**ADDENDUM THREE  
EAST LAKE PARK IMPROVEMENTS  
WATER QUALITY PROJECT  
CONTRACT NO. S-15-016  
CITY OF CHATTANOOGA, TENNESSEE**

**The following changes shall be made to the Contract Documents, Specifications, and Drawings:**

CITY OF CHATTANOOGA, TENNESSEE  
DEPARTMENT OF PUBLIC WORKS  
EAST LAKE PARK  
WATER QUALITY IMPROVEMENT PROJECT

ALTERNATE 1  
ACCESSIBLE PARKING AND PATHWAYS  
C-15

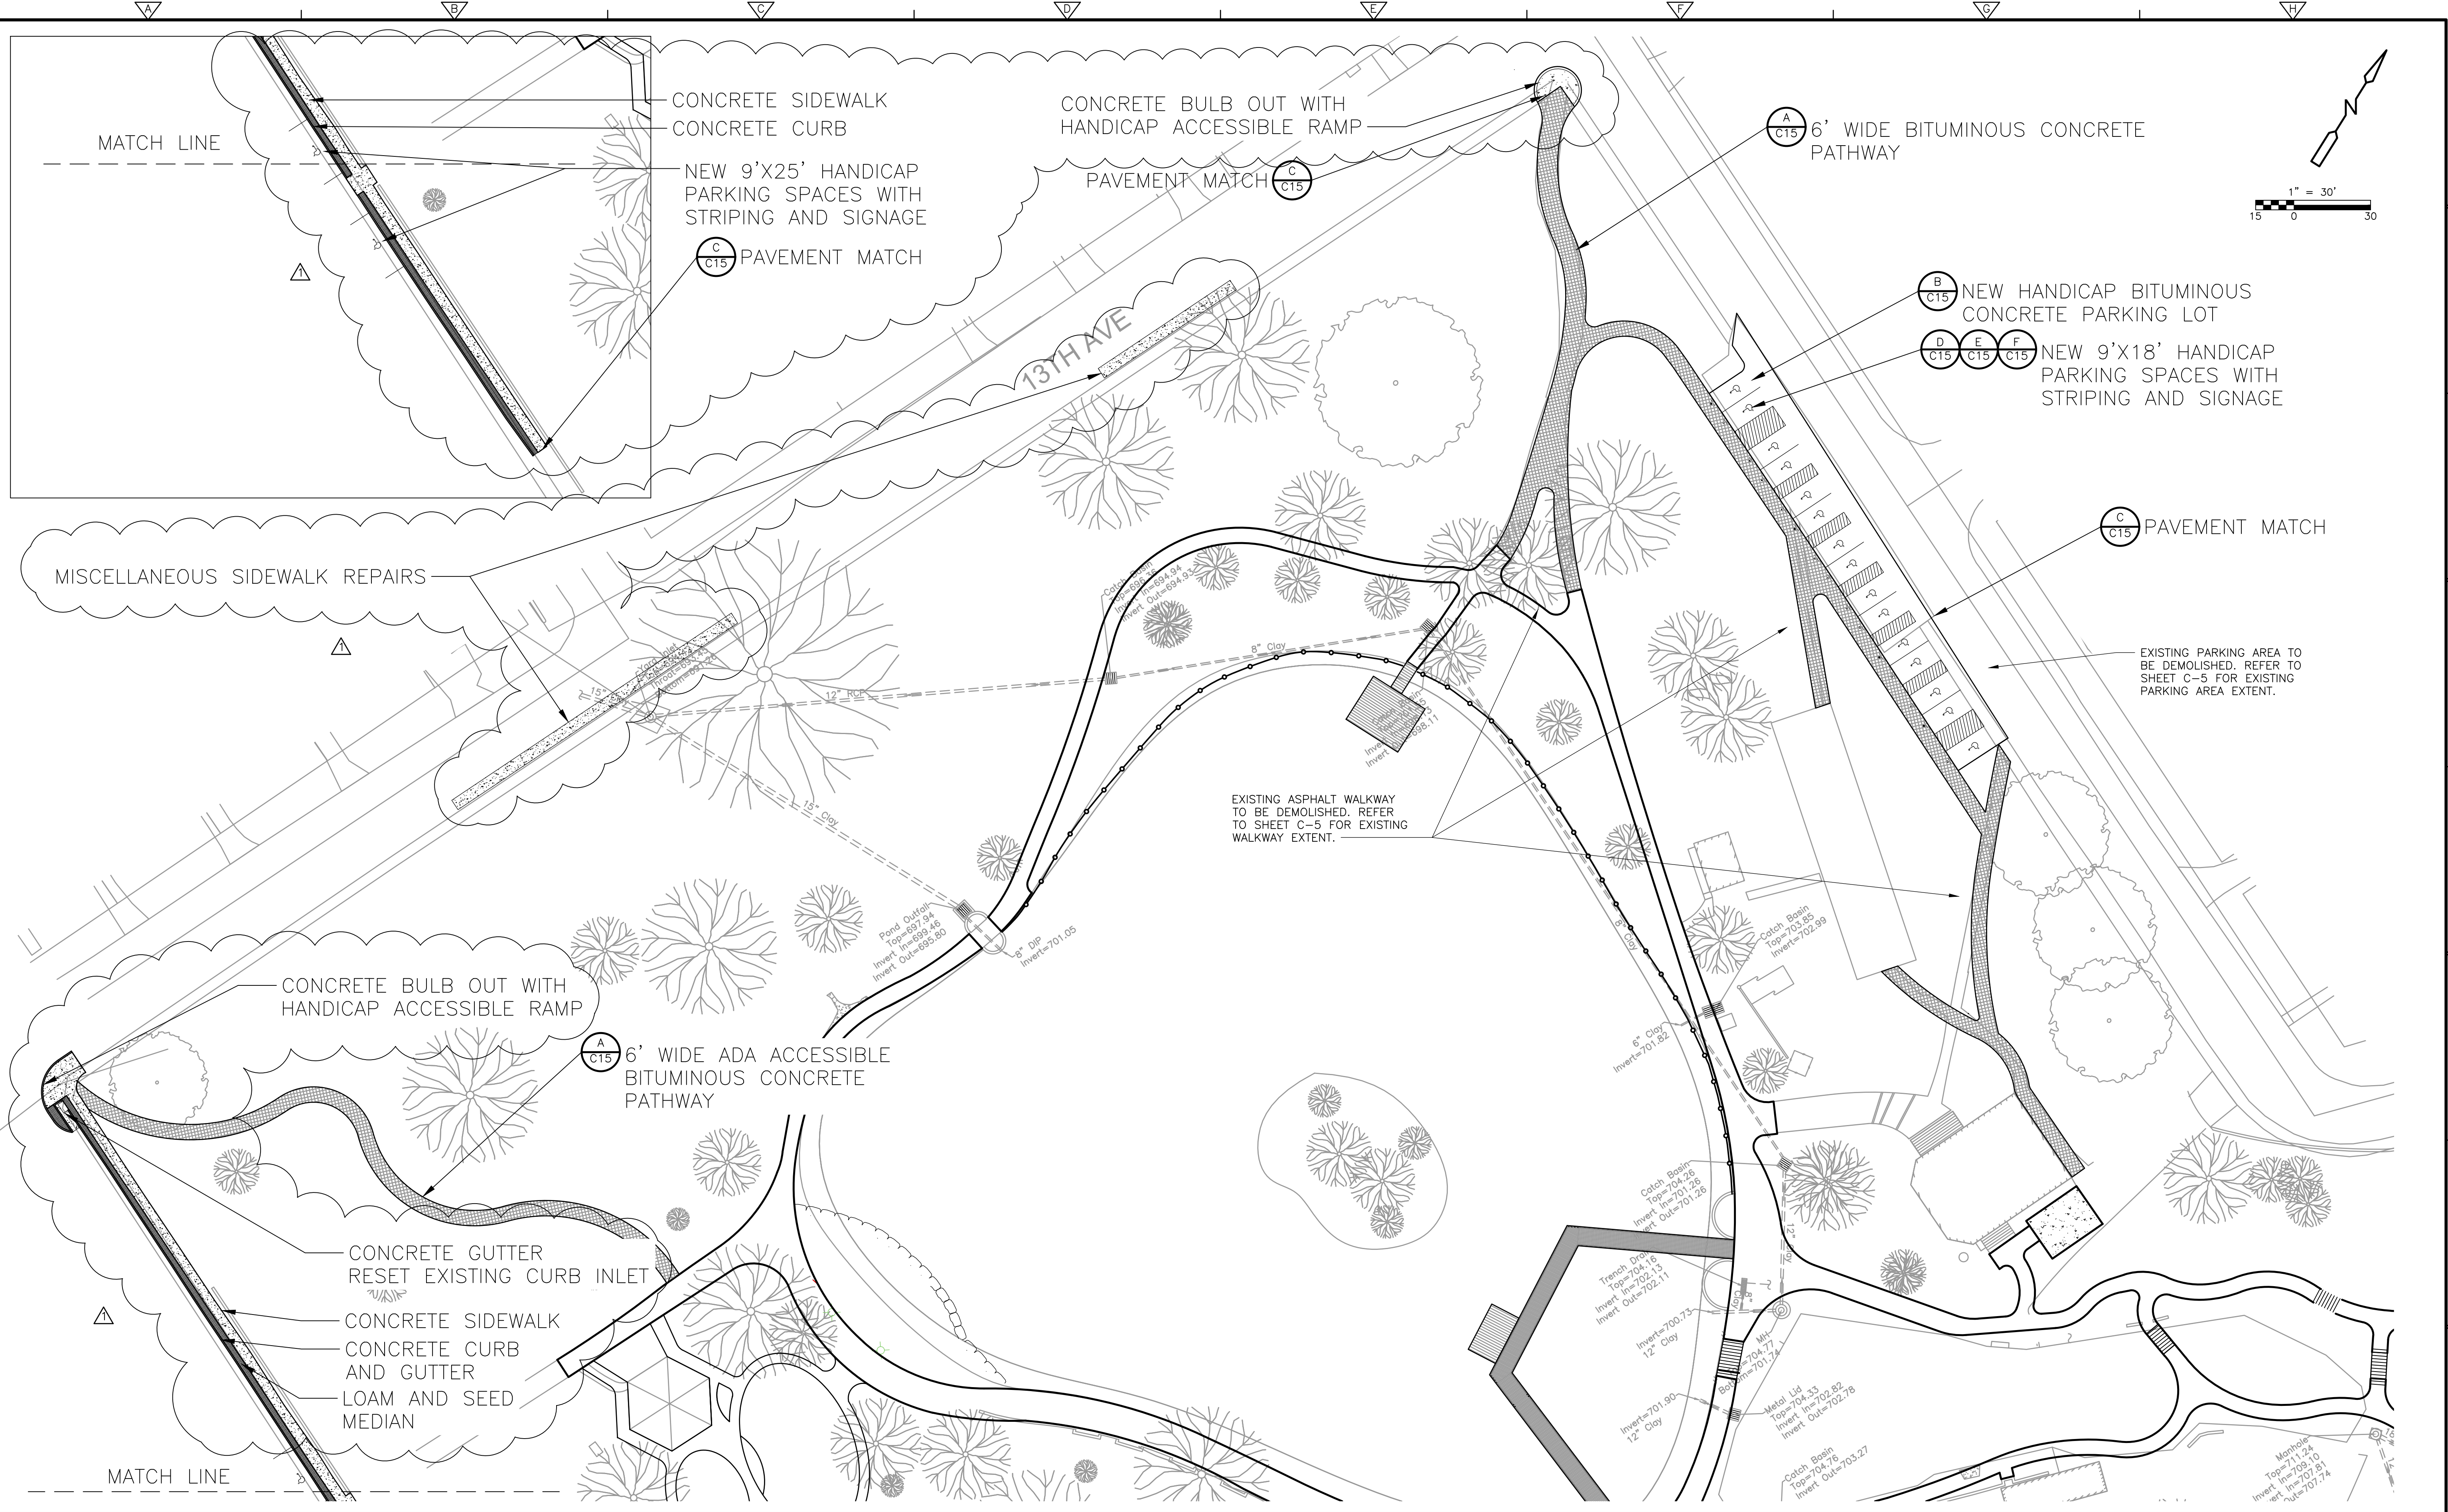
- I. Remove Sheet C-15 from original bid set and replace with Revised Sheet C-15, which includes right-of-way sidewalk repair/replacement, concrete bulb outs (2) with handicap accessible ramps, and two additional handicapped parallel parking spaces along E 36<sup>th</sup> Street.**

REV. NO.	DATE	DRWN	CHKD	REMARKS
1	11.8.18	SF	DM	SIDEWALK IMPROVEMENTS
